SSDA Mods

1.1 Facade Materiality

Modification 1 to SSDA

Proposed Northern Façade [SMCSWSPS-FOS-OSN-AT-DWG-960004 Rev E]

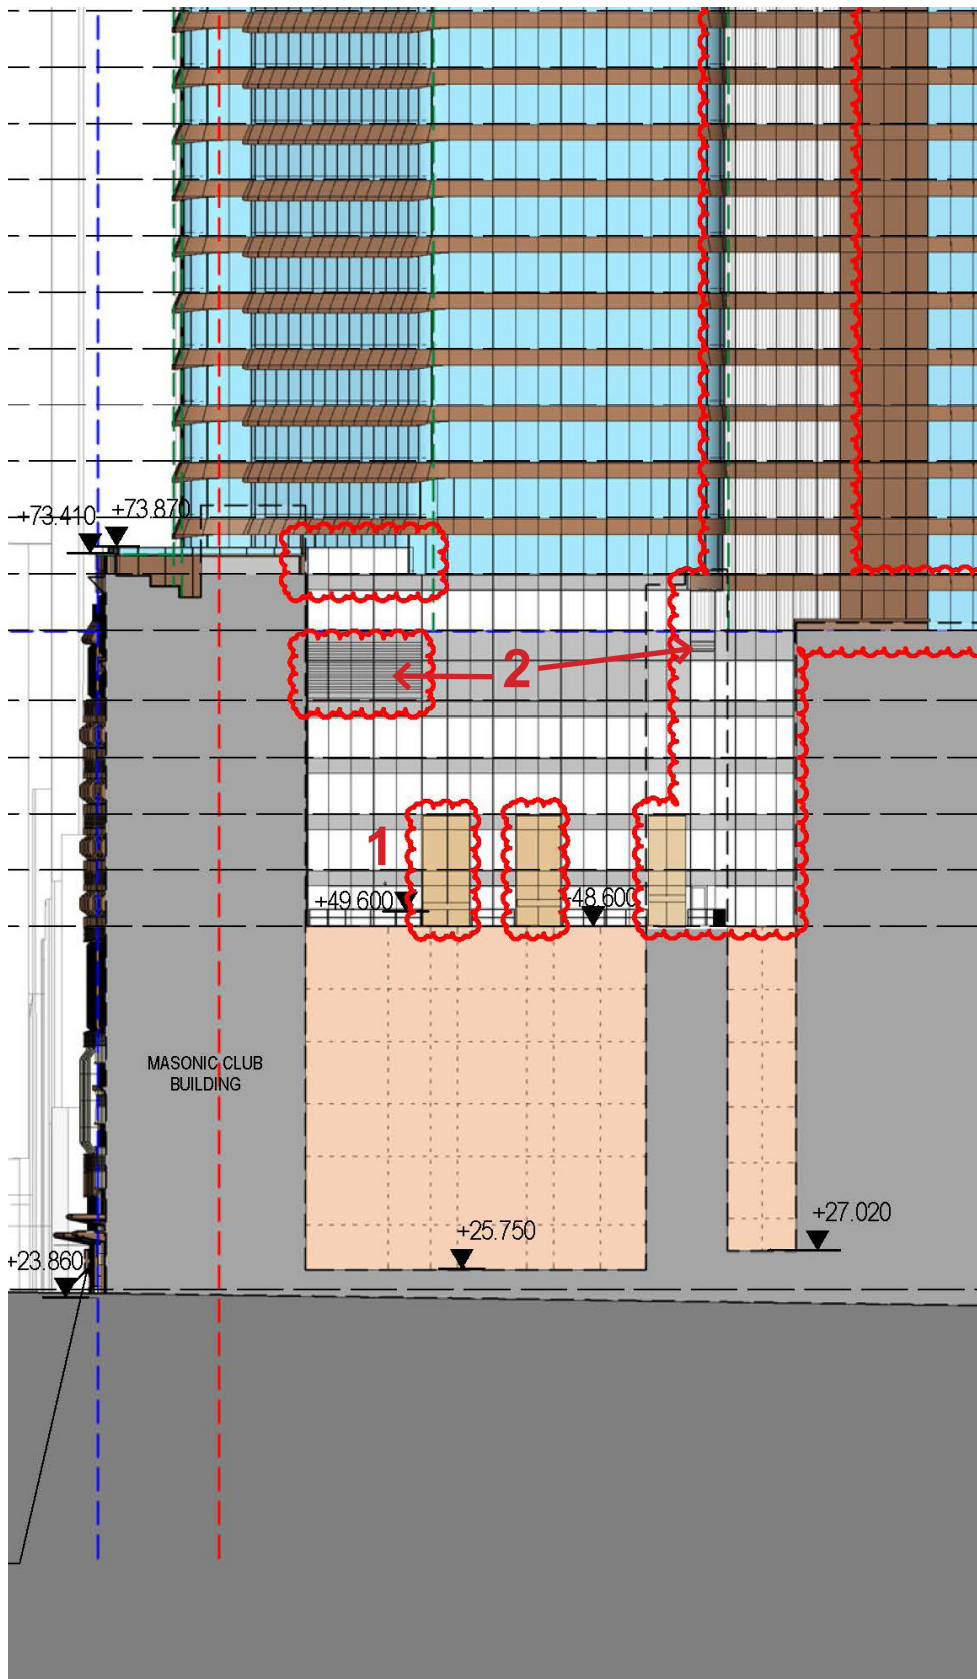
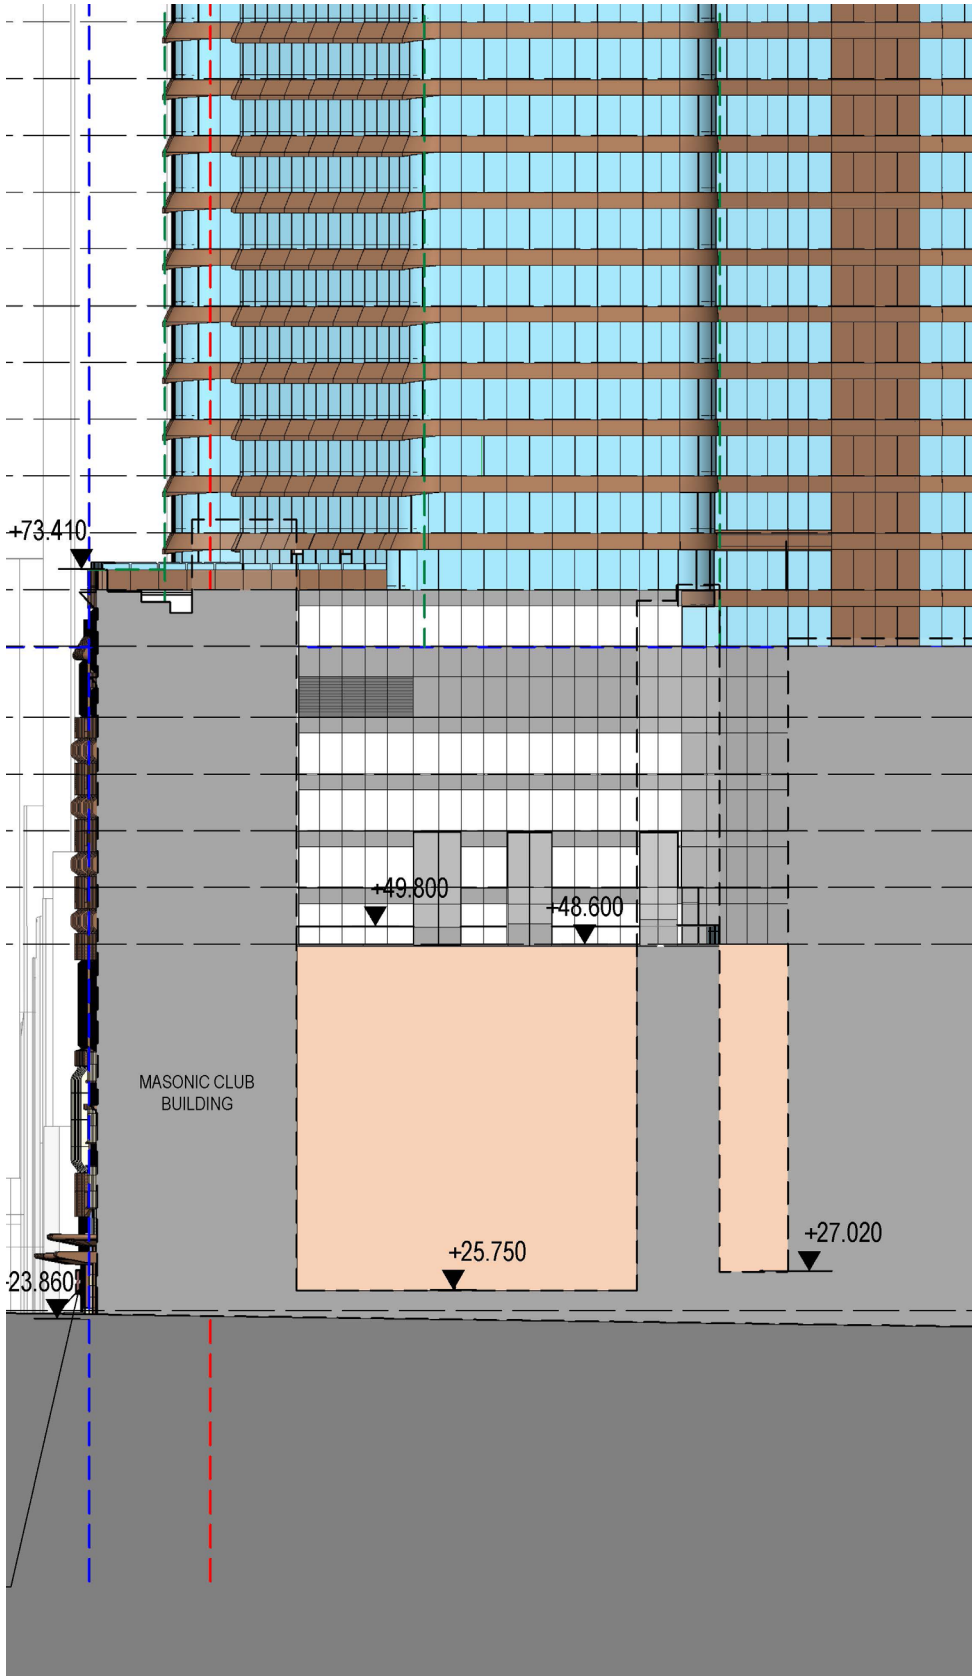
- 1. White spandrel glazing noted on the Northern Light well columns is clarified to be Metal Cladding as it has been incorrectly coloured on the SSDA documents.
- 2. Louvre extent updated to match mechanical intake / exhaust layout.
- 3. Fluted Glazing added to key plan

Proposed Northern Façade [SMCSWSPS-FOS-OSN-AT-DWG-960004 Rev E]

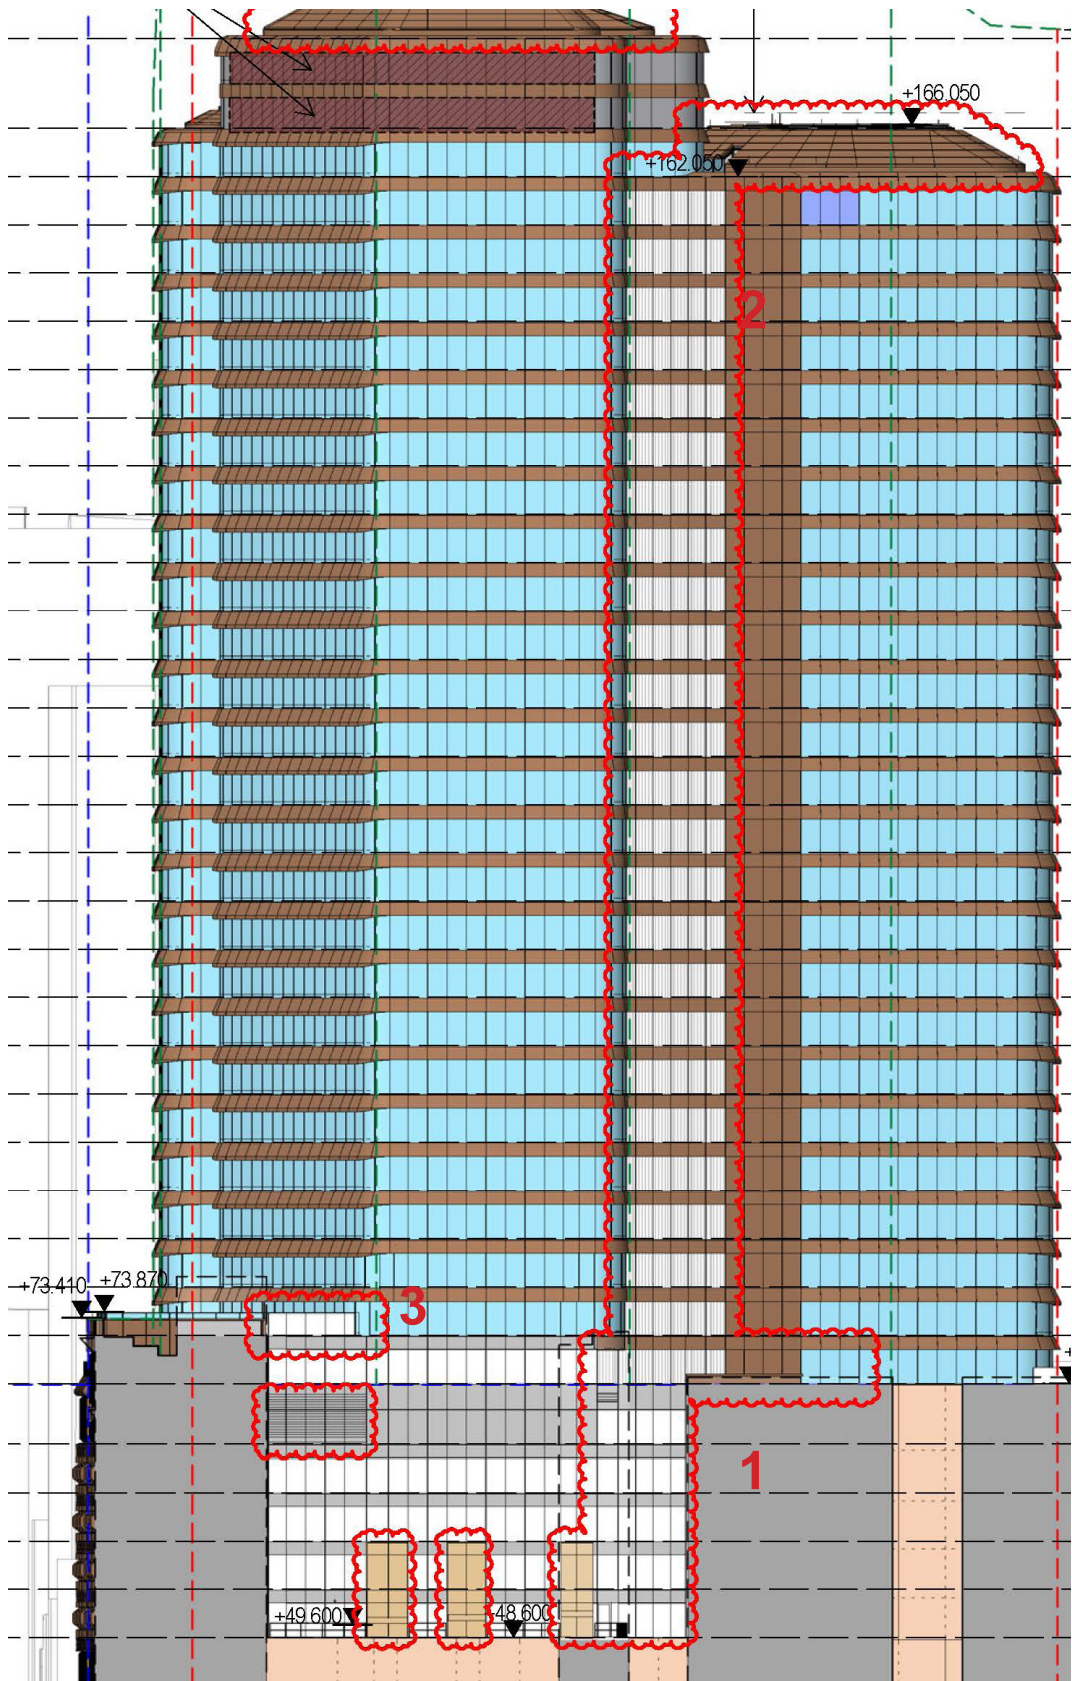
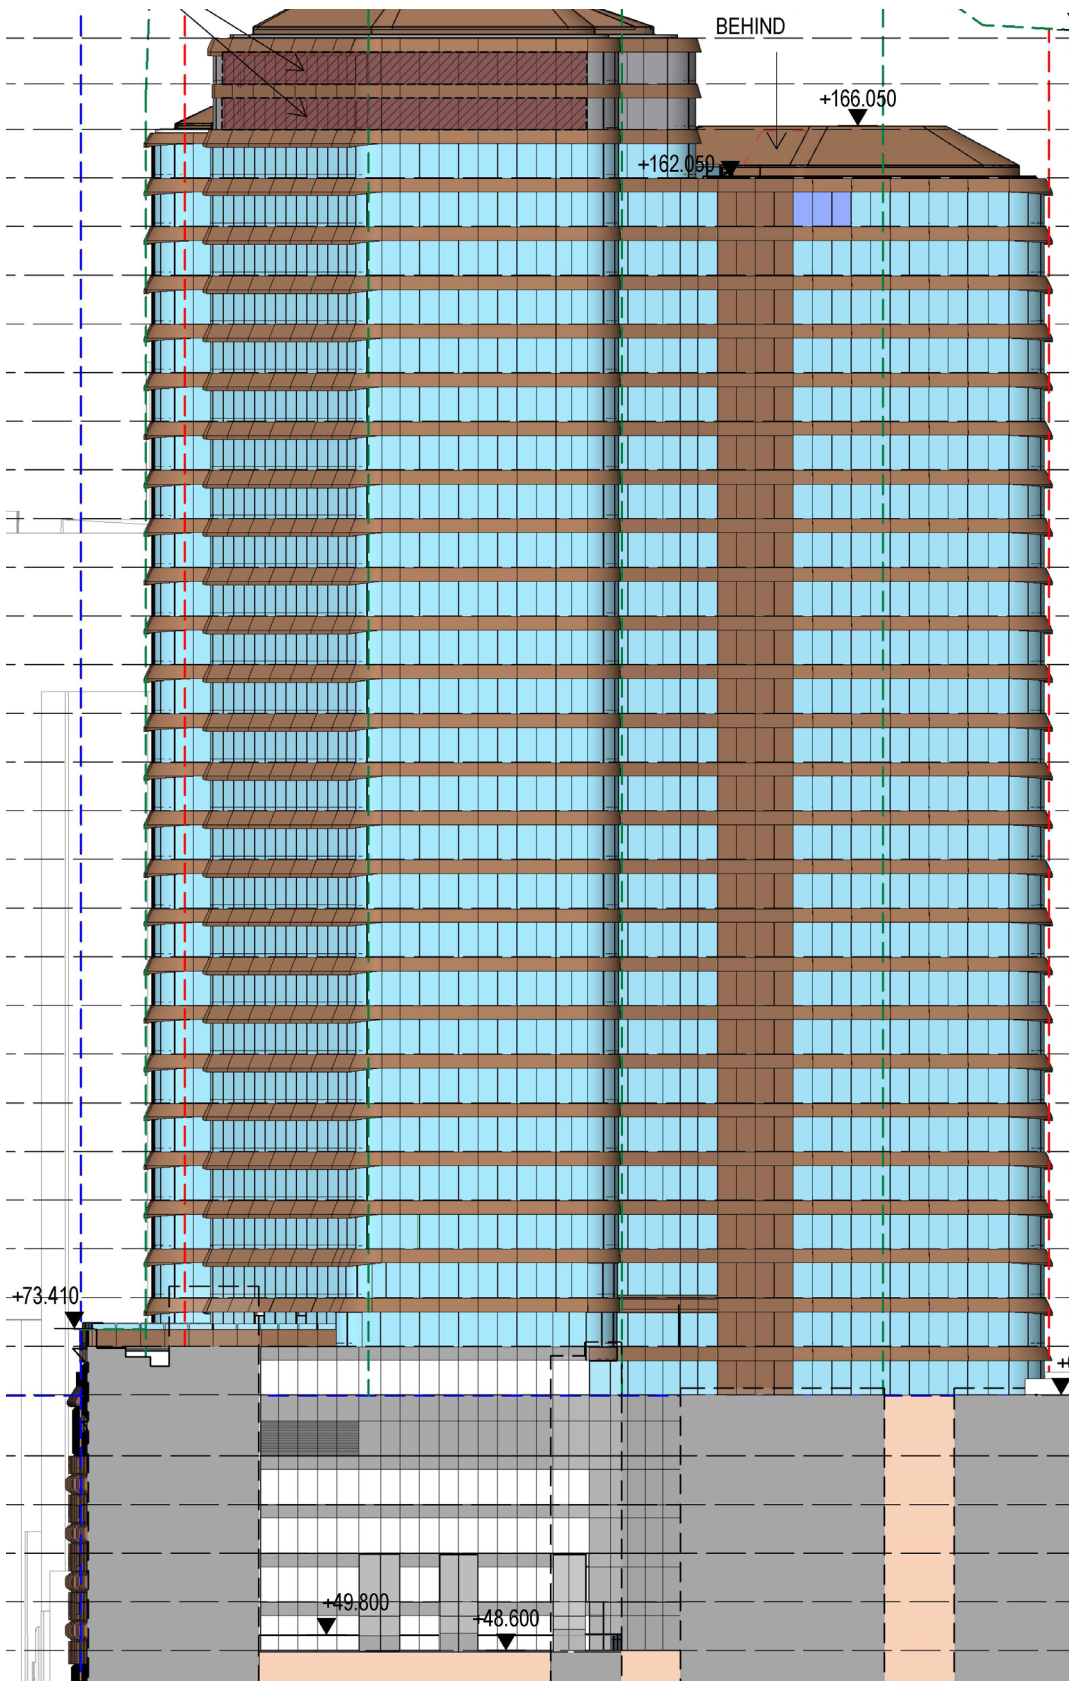
- 1. White spandrel glazing on the northern facade is modified to be translucent curtain wall on North facing adjoining neighbours.
- 2. The approved plans show a glass curtain wall adjacent to the amenities and this has been corrected to a fluted glass. This will have the same neutral colour and appearance as originally intended.
- 3. Balustrade has been updated to reflect a continuation of the translucent glazing below.

Proposed Modification: North Elevation

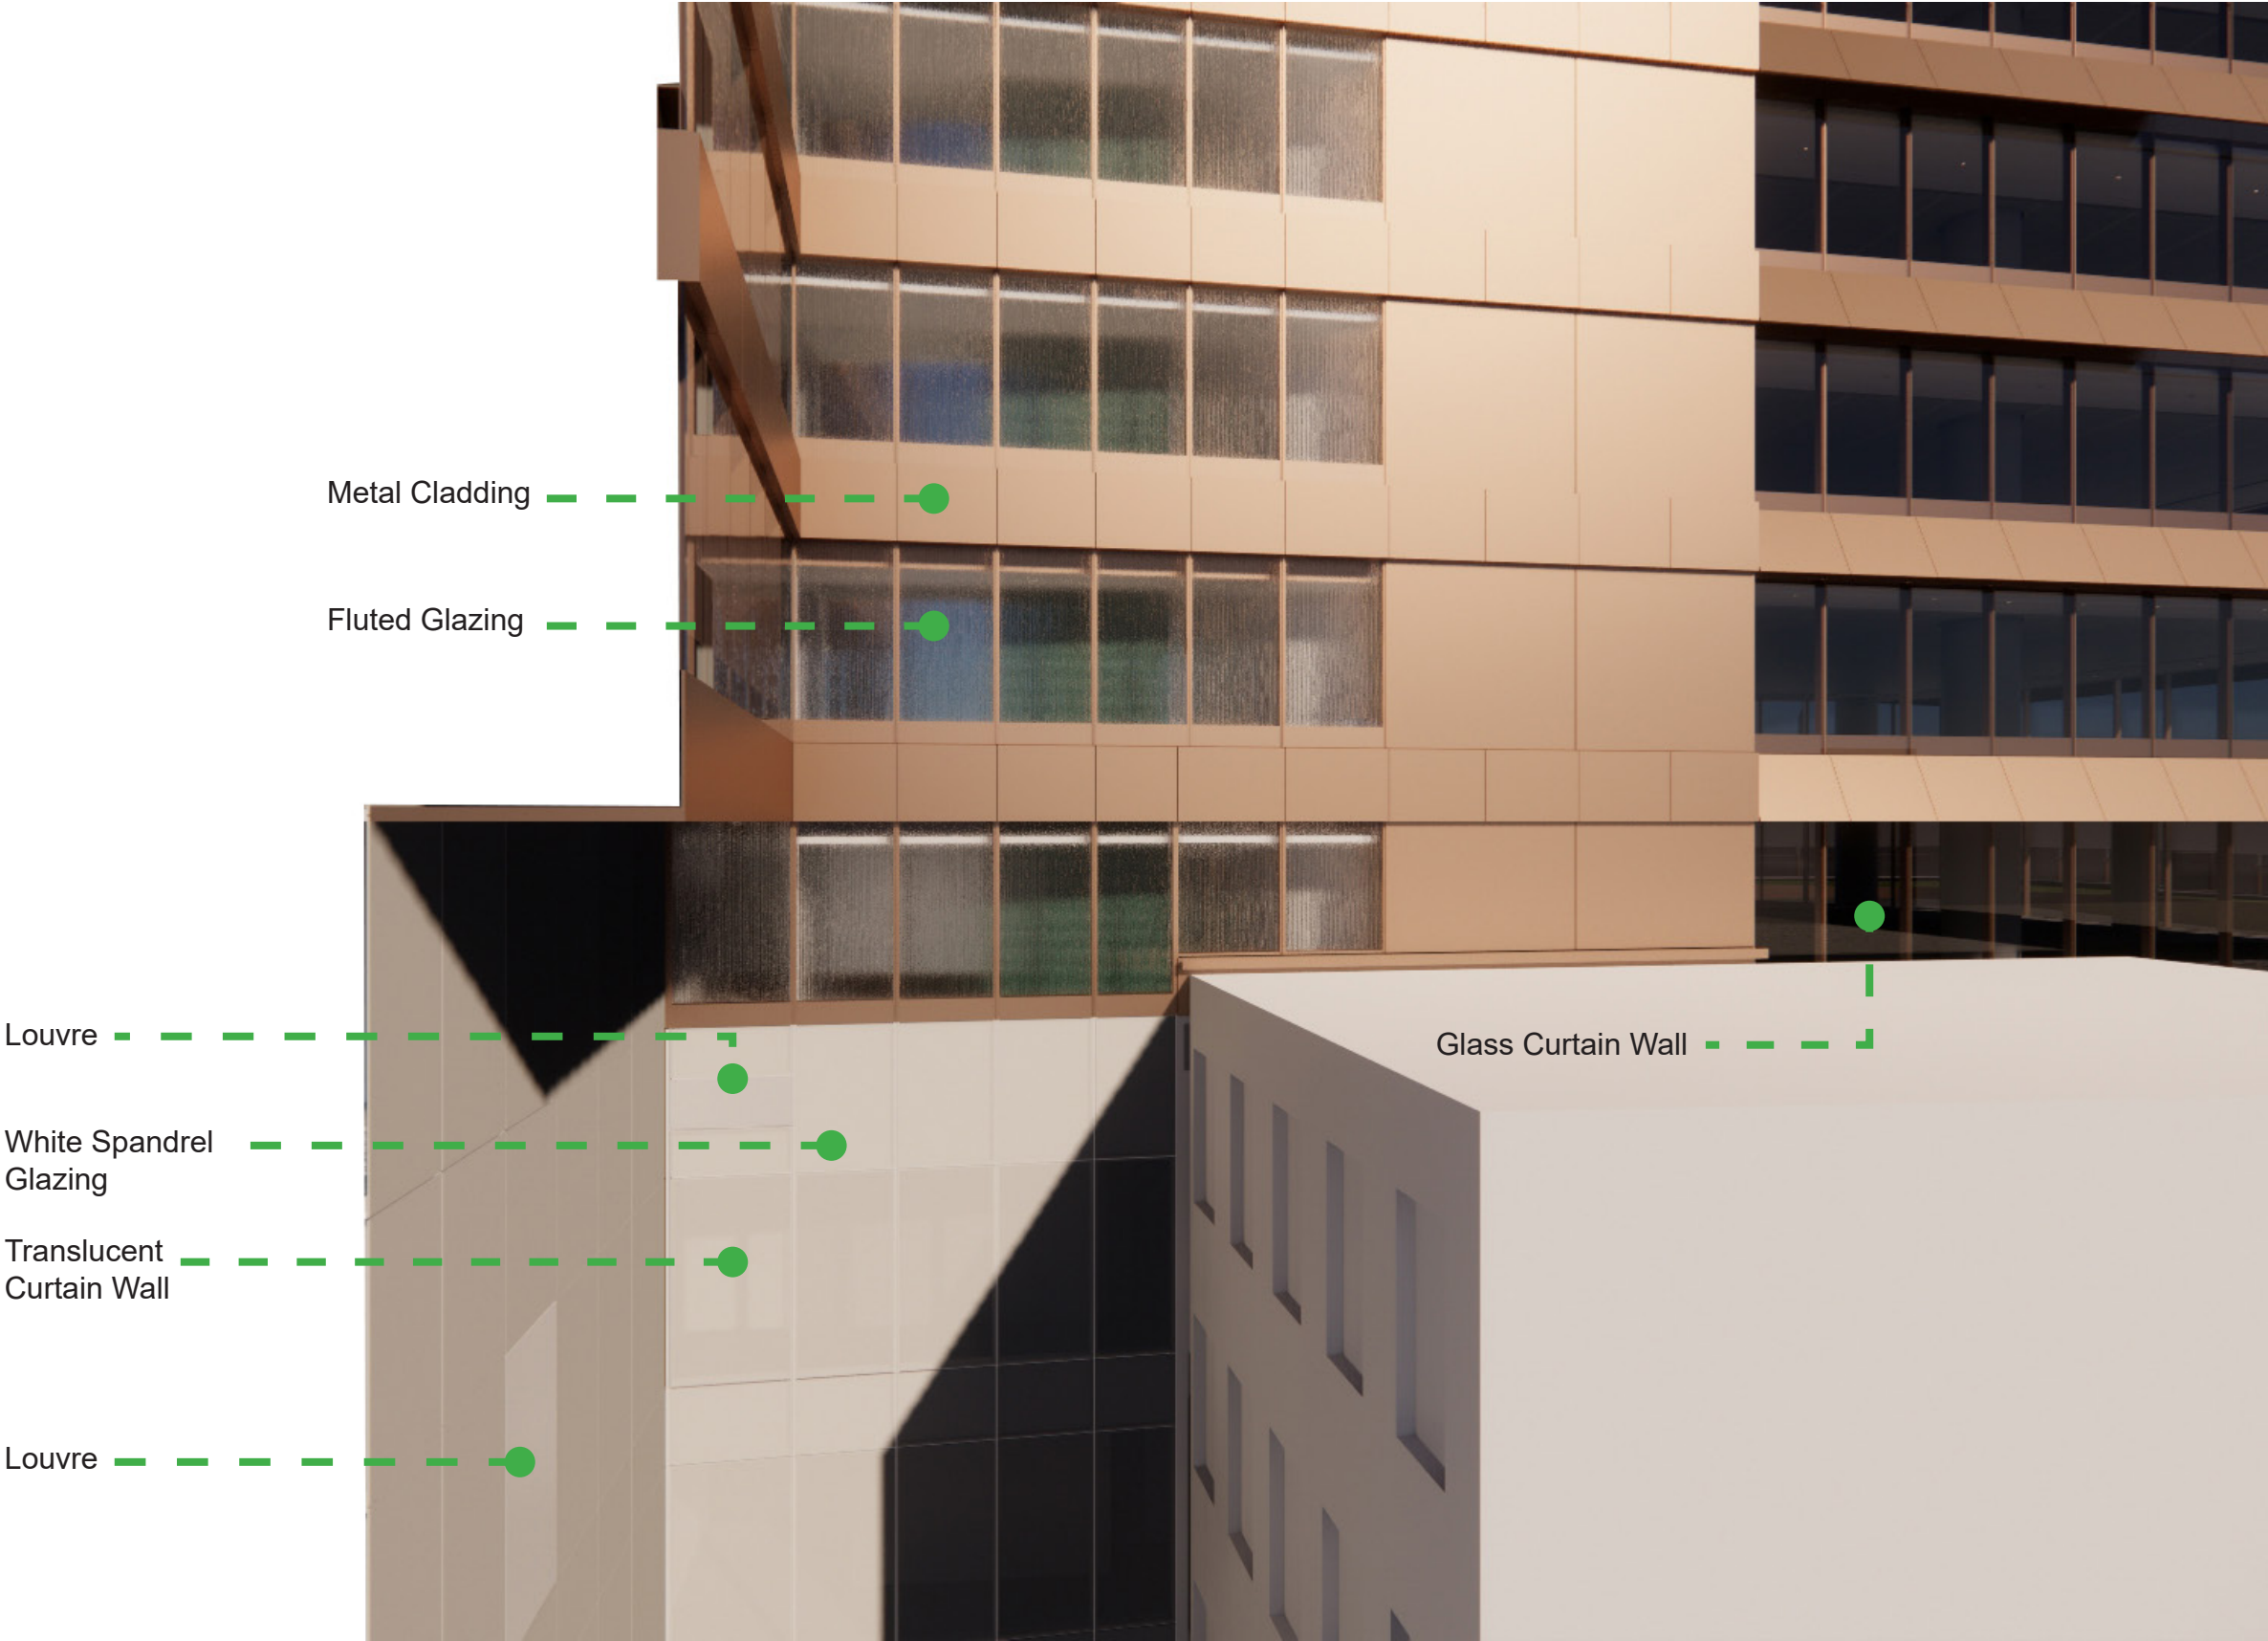
The modifications proposed to the adjoining light well is consistent with the intent of the original SSDA Proposal, as the form will be the same there will be no impacts on the original SSDA amenity proposed. The adoption of translucent glass where the office amenities and adjoining office facades are located is an enhancement to the privacy of the development occupants and the neighbouring occupants.
